RE: **Lot 3 Block 9 Unit 5 Volcano Cliffs SAD 227**
6208 Keyenta Pl NW
Grading and Drainage Plan
Engineers Stamp Date 7/5/17 (E10D0031)
Pad Certification Dated 7/7/17

Based upon the information provided in your submittal received 7/5/17, this plan is approved for Building Permit.

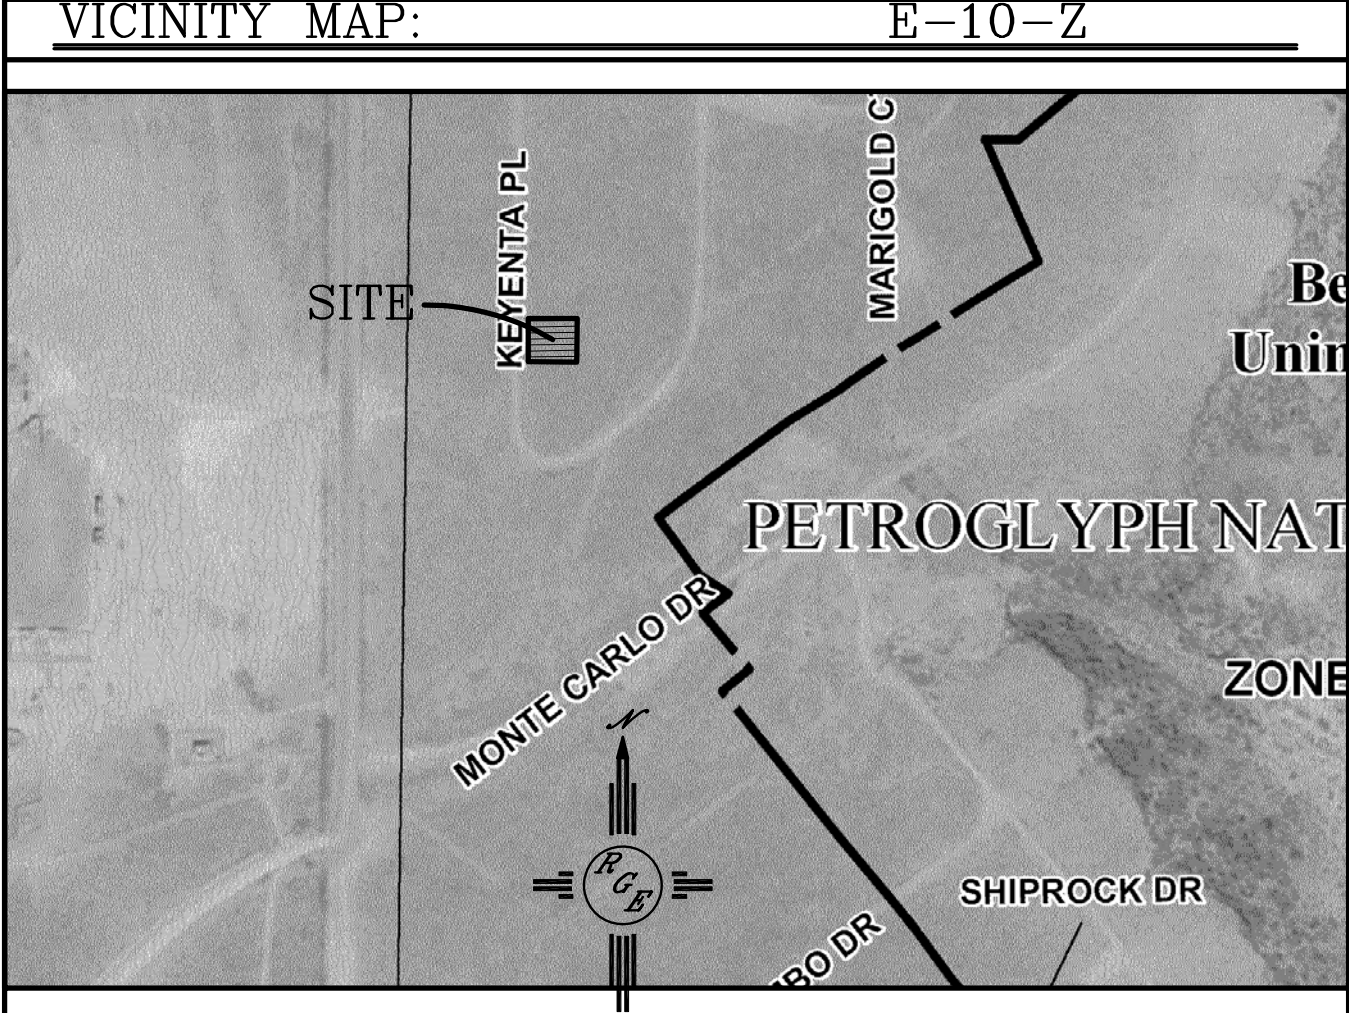
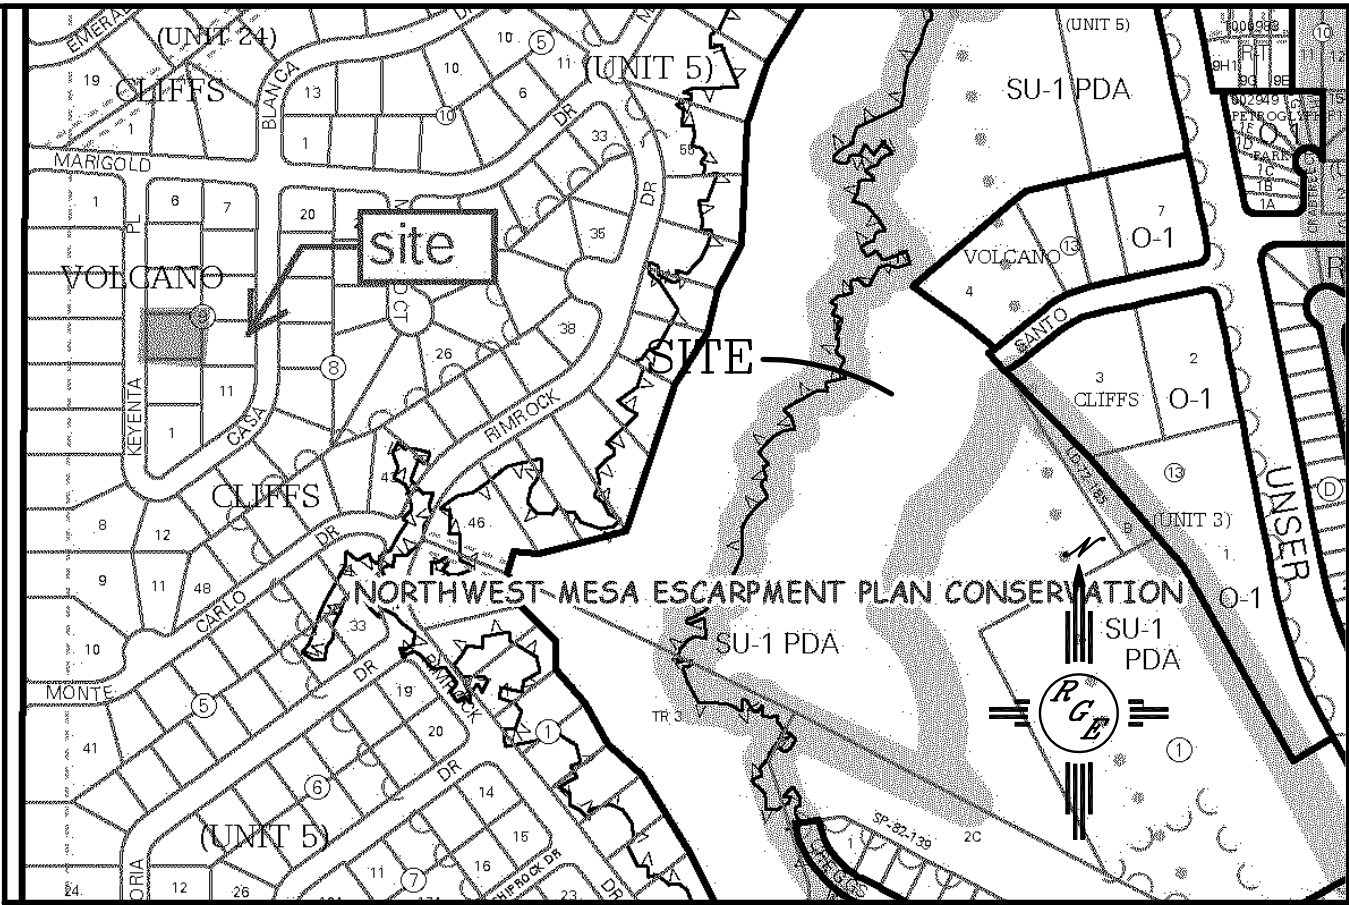
Please inform the builder to attach a copy of this approved plan to the construction sets in the permitting process prior to sign-off by Hydrology. Also, notify the owner/contractor that a separate permit for any fence is required, and this is the plan to be used for the placement of the fence.

Prior to Certificate of Occupancy release, Engineer Certification per the DPM checklist of this plan will be required.
